Recall Bulletin

PRODUCT SAFETY RECALL

SUBJECT: Electric Power Steering Assist

MODELS: 2004-2006 Chevrolet Malibu, Malibu Maxx
2008-2009 Chevrolet Malibu
2005-2006 Pontiac G6
2008-2009 Pontiac G6
2008-2009 Saturn Aura
Equipped with Electric Power Steering

3824308

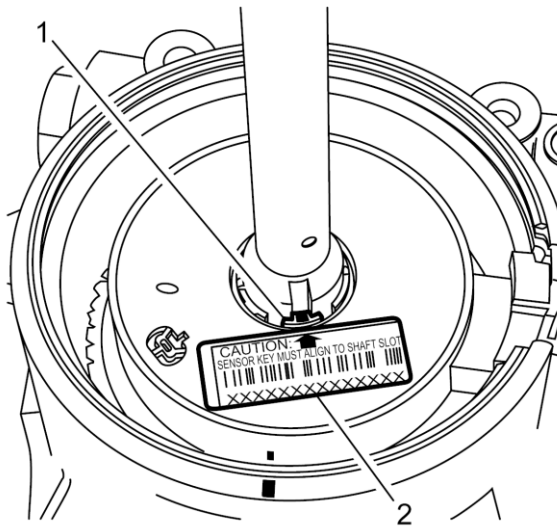
3. Document the last 9 digits of the NEW steering shaft torque sensor on the vehicle repair order. The serial number is located on the bottom of the caution label (2).
